**City of Hamilton**  
**PUBLIC WORKS COMMITTEE REVISED**

<b>TO:</b>	Chair and Members Public Works Committee
<b>COMMITTEE DATE:</b>	June 17, 2024
<b>SUBJECT/REPORT NO:</b>	Woodward Water Treatment Plant Phase 2 Upgrades (PW22078(a)) (City Wide)
<b>WARD(S) AFFECTED:</b>	City Wide
<b>PREPARED BY:</b>	Stuart Leitch (905) 546-2424 Ext. 7808
<b>SUBMITTED BY:</b>	Nick Winters Director, Hamilton Water Public Works Department
<b>SIGNATURE</b>

The Review Assignment, attached as Appendices “B”, “C”, “D” and “E” to Report PW22078(a) includes key areas that are deemed critical to the success of the Water Treatment Plant Phase 2 upgrades with a focus on reviewing the Phase 2 Conceptual Design components developed in 2022. The Review Assignment considered whether certain portions of the work could be deferred as a future phase to reduce project scope or to defer capital expenditures. The Review Assignment concluded that the Water Treatment Plant Phase 2 Capital Program should be split into Phases 2A and 2B which will provide project staff the ability to prioritize key process upgrades that protect public health ahead of a capacity expansion to support Hamilton’s growth and development.

Figure 2-2: Summary of Existing Construction Schedule

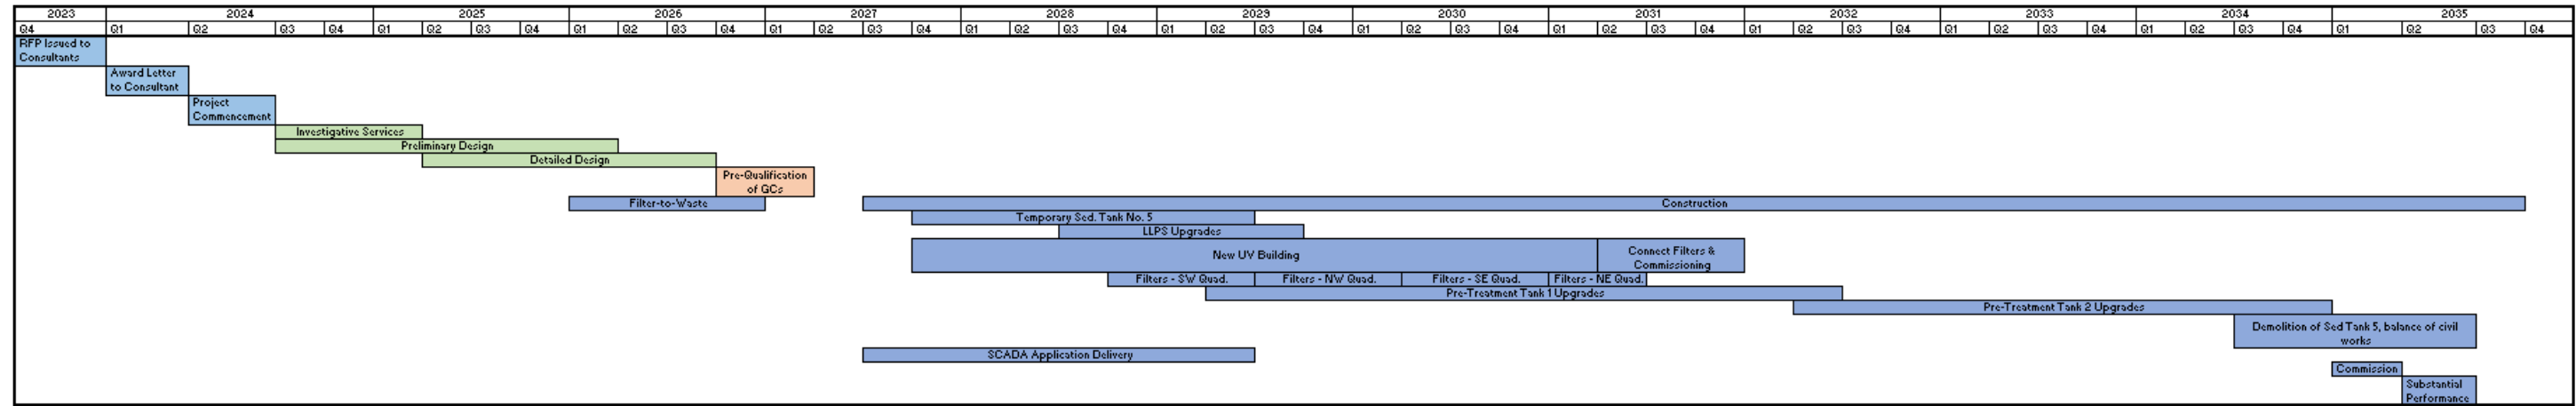
A high-level summary of the existing schedule as presented in the AECOM CDR is presented in Figure 2-2. Significant overlapping works are likely to increase complexity of construction and increase constructability risks.

The proposed construction schedule (**Figure 2-2**) requires the plant to operate in an off-normal flow configuration, resulting in higher than typical flowrates expected in portions of the plant. Stantec has identified two hydraulic increase cases that we recommend be investigated for the presence of bottle necks and mitigation methods elucidated before construction starts.

Figure 3-1: Possible Optimized Phase 2 Construction Schedule

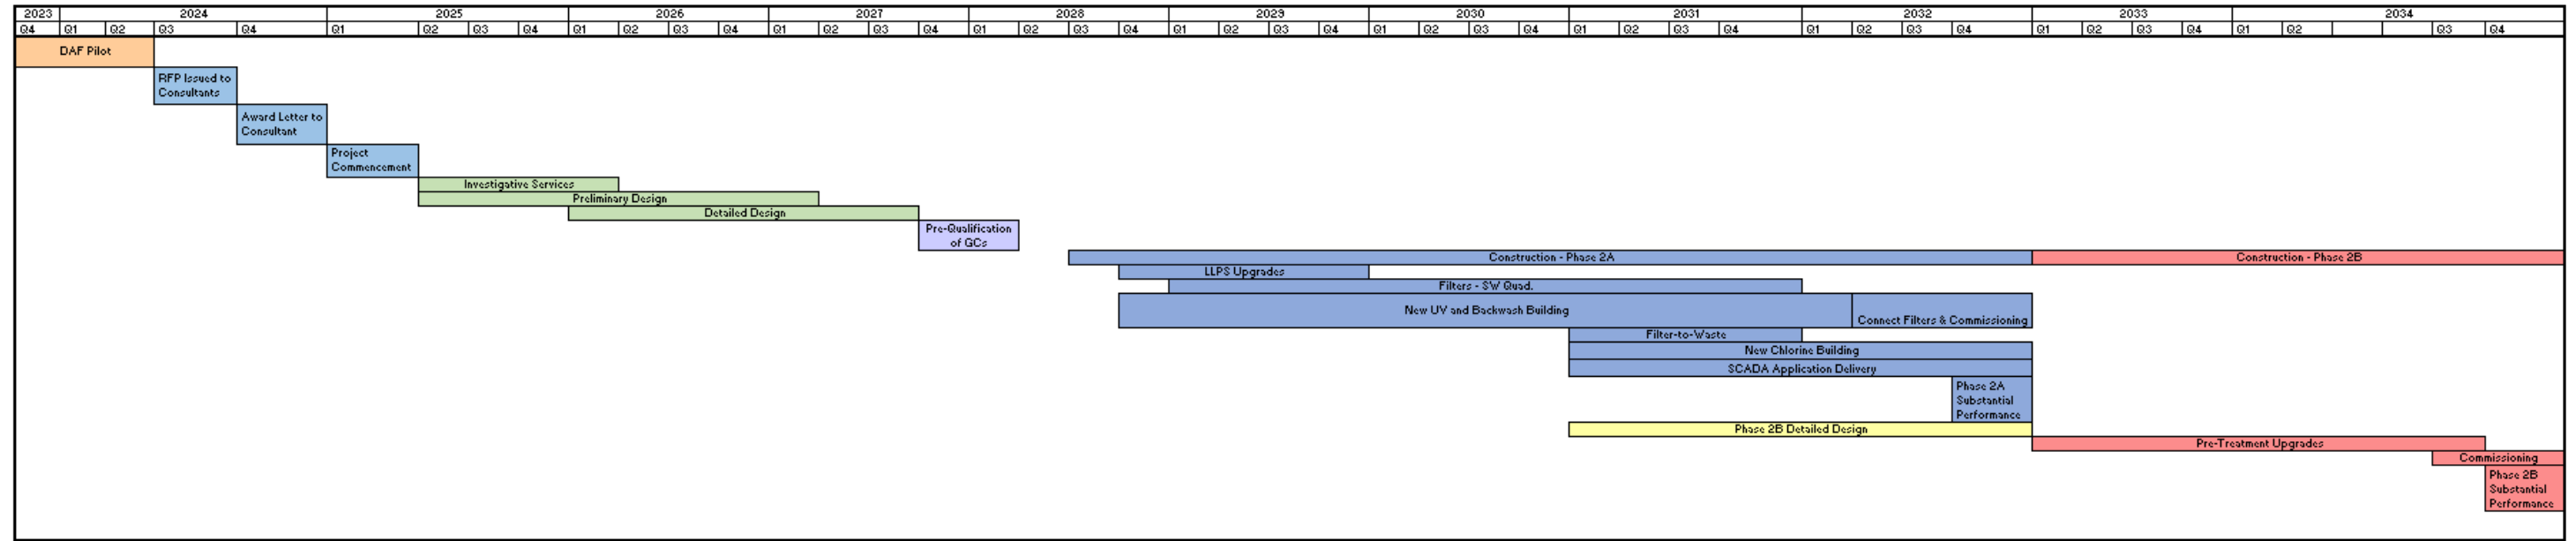
Modifying the phasing plan and completing pre-treatment upgrades after disinfection and filtration upgrades will allow more time for selection of the preferred sedimentation technology. It is critical to select the preferred pre-treatment technology and develop a feasible conceptual design prior to initiating detailed design in order to allow for accurate cost estimates, detailed proposal submissions, and selection of an appropriate experienced design firm. The existing design for enhanced sedimentation upgrades with plate settlers requires complex and substantial construction, costs, and staging for a technology that may not be the best fit for this facility and budget. A possible optimized schedule for the Phase 2 Upgrades is shown in **Figure 3-1**.

The low lift pumping station upgrades, flocculation, and sedimentation tank upgrades including temporary sedimentation tank no. 5 can be optimized or shifted in the schedule if DAF were to be implemented. Moving the disinfection and filtration upgrades ahead in the schedule may provide more operational flexibility during the pre-treatment upgrades. A possible optimized schedule is shown in Figure 3-1. The schedule splits the design and construction assignments into two phases, Phase 2A and Phase 2B, to provide additional time to select a preferred sedimentation technology. Phase 2A involves the LLPS, disinfection and filtration upgrades. Detailed design for the pre-treatment upgrades (Phase 2B) can then occur concurrently with the final two years of Phase 2A. The pre-treatment upgrades schedule can be significantly optimized with an alternative technology such as DAF, eliminating the need for a 5<sup>th</sup> temporary sedimentation tank, road relocation and associated civil works. Pre-treatment upgrades are shown to occur over a 3-year period, resulting in completion of the Phase 2 project 1 year earlier than originally scheduled. The optimized schedule will prevent multiple sedimentation tanks from being offline concurrently with one or two filter quadrants down, prioritizing protection of public health and decreasing likelihood of non-compliance events.

**Figure 4-1: Proposed UV Building Infrastructure and Layout (Source: AECOM Conceptual Design, 2021)**

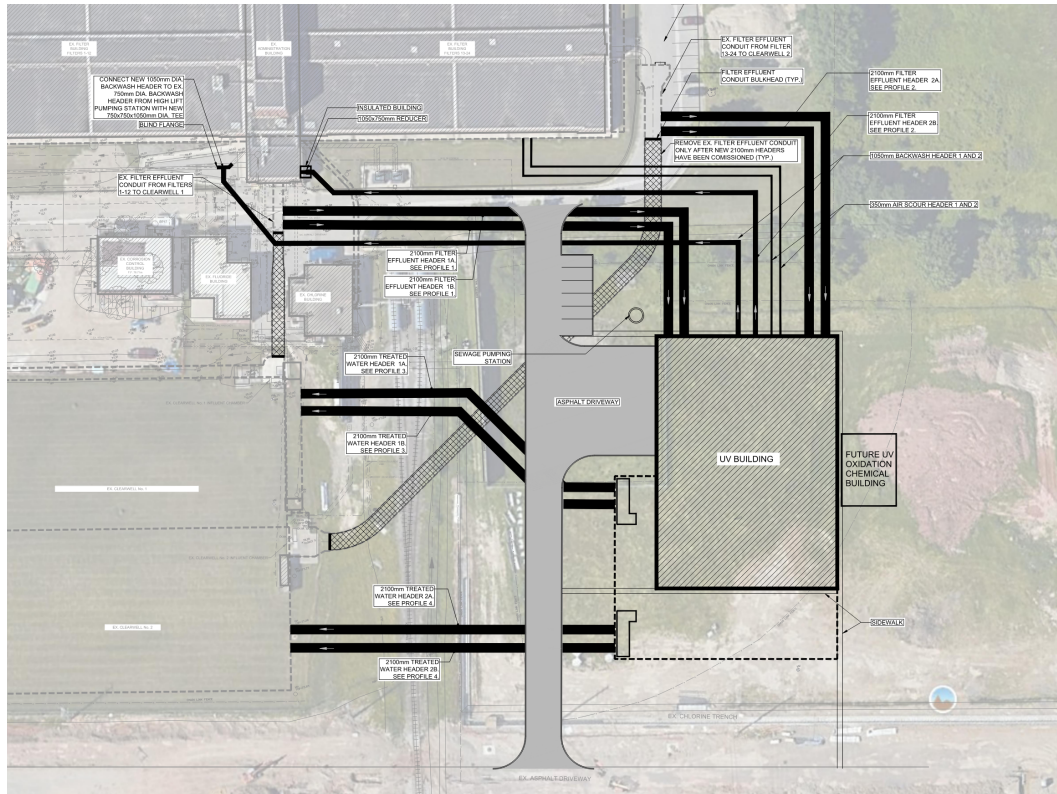
The below image (**Figure 4-1**) is the UV Building in the proposed location complete with all major new infrastructure connecting it to the existing treatment train. At first glance, the piping arrangement appears to be convoluted, where portions can be deleted in full, and others simplified. It is worthwhile clarifying that we have assumed that all major pipe systems have been twinned to eliminate single points of failure concerns the City might have within the treatment process.

The UV outlet at the southerly portion of the building connecting to existing Clearwell No. 2 results in an unnecessarily long downtime to Clearwell No. 2. The City has already completed modifications that permit flow into either clearwell through one common influent channel. It should be noted that based on the current CT calculator, the City does not count CT provided through the clearwells, therefore without clearwell 2 in operation, there is no impact to plant capacity.

**Figure 4-2: Alternative Conduit Connections (Drawing Source: AECOM Conceptual Design, 2021)**

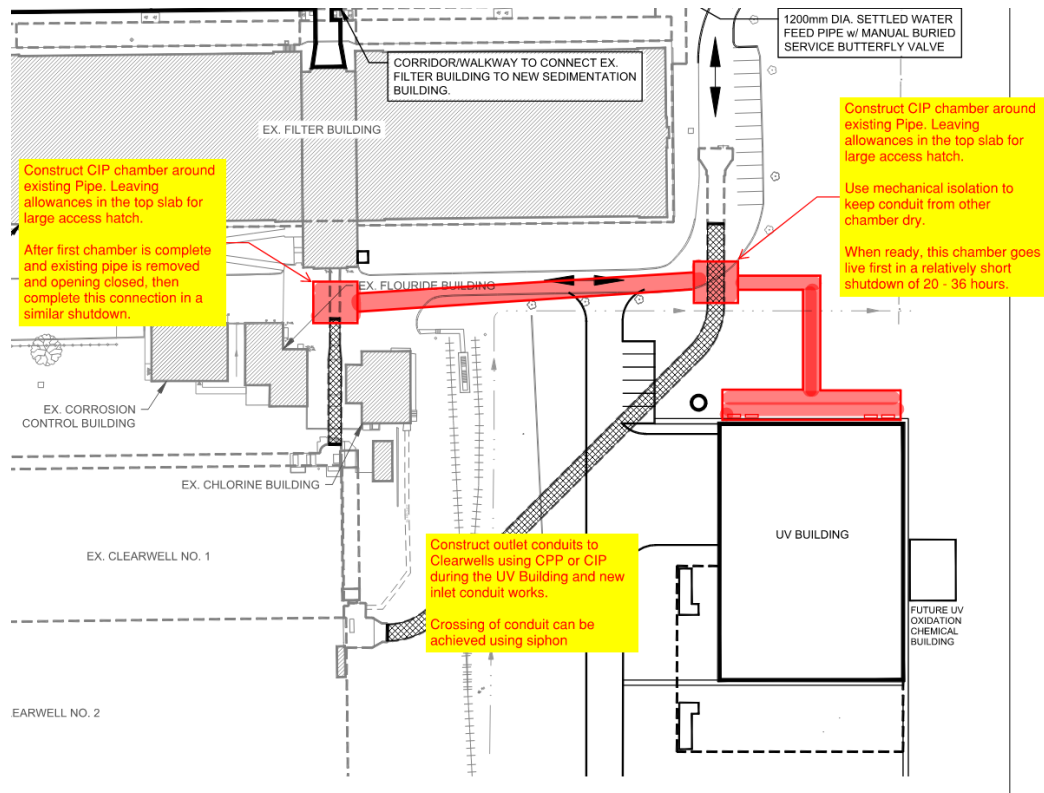
Flexibility could also be realized when connecting to the existing conduit systems by first constructing a CIP chamber around the existing conduits whilst they remain in service, uninterrupted by the construction process as shown in **Figure 4-2** below. This would allow all final connections to be made and backfilled before the system is connected live.

The final connection would be a simple short duration shut down to remove a section of existing conduit, making the system live. This is a critical part of the project and careful consideration should be given to the ease of removal of these existing conduits during detailed design. Room for wire saws, and concrete removal should be considered to keep the overall tie-in between 20 and 36 hours of downtime.

**Figure 4-3: Proposed Sedimentation Tank Structural Works (Source: AECOM Conceptual Design, 2021)**

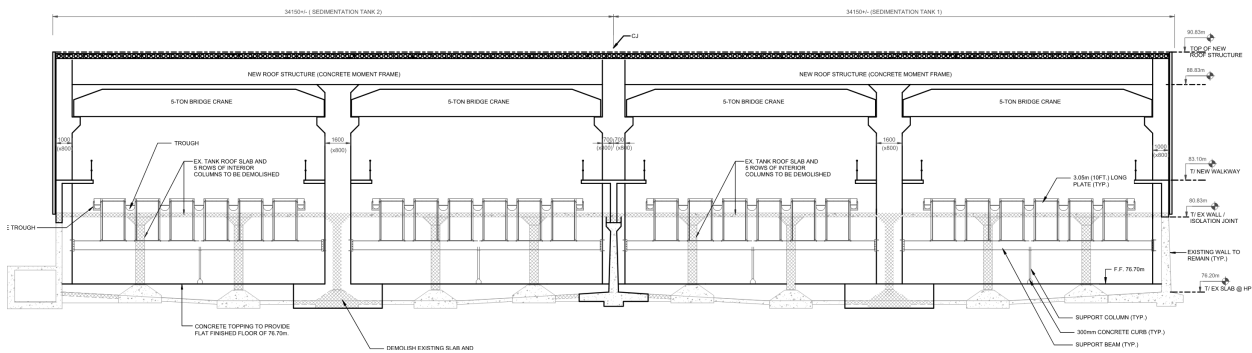
**Figure 4-3** provides a visual of the large slab penetrations, raised walls, and new roof construction in the current conceptual design.

**Figure 4-5: FTW Piping Conceptual Design (Source: CH2M Filter-to-Waste report, 2021)**

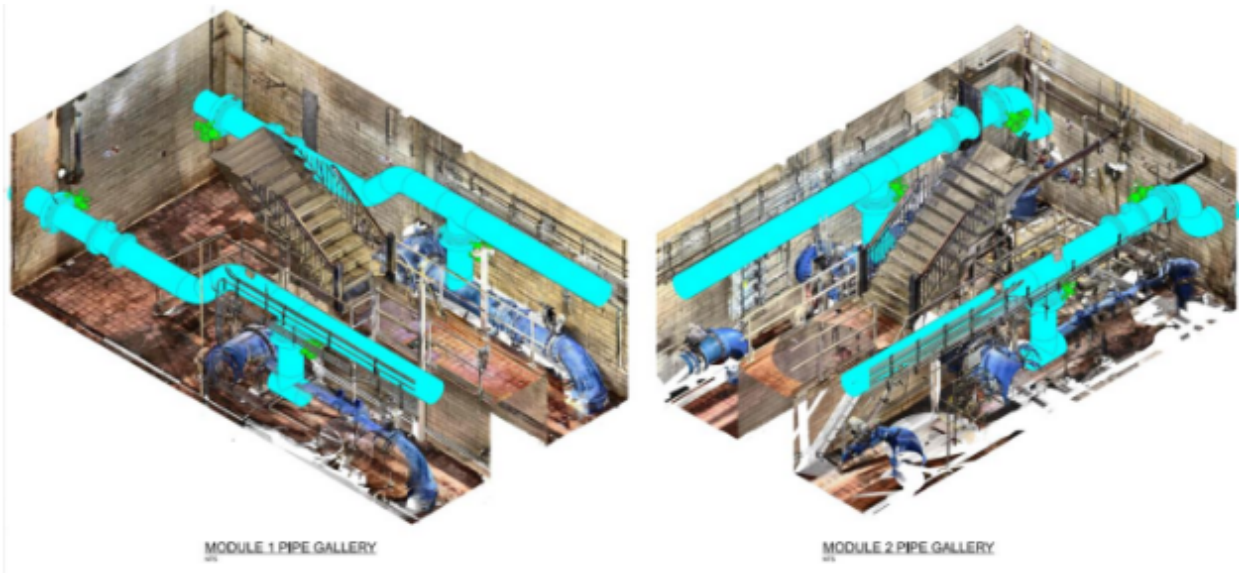
possible off-spec water. **Figure 4-5**, from the Jacobs FTW conceptual design report, shows the proposed piping installation layout.

At face value, integrating the FTW piping within this pipe gallery may appear to be the easiest way to implement the system, but it will not be without careful staging within a congested area as shown in the photo in **Figure 4-6**.
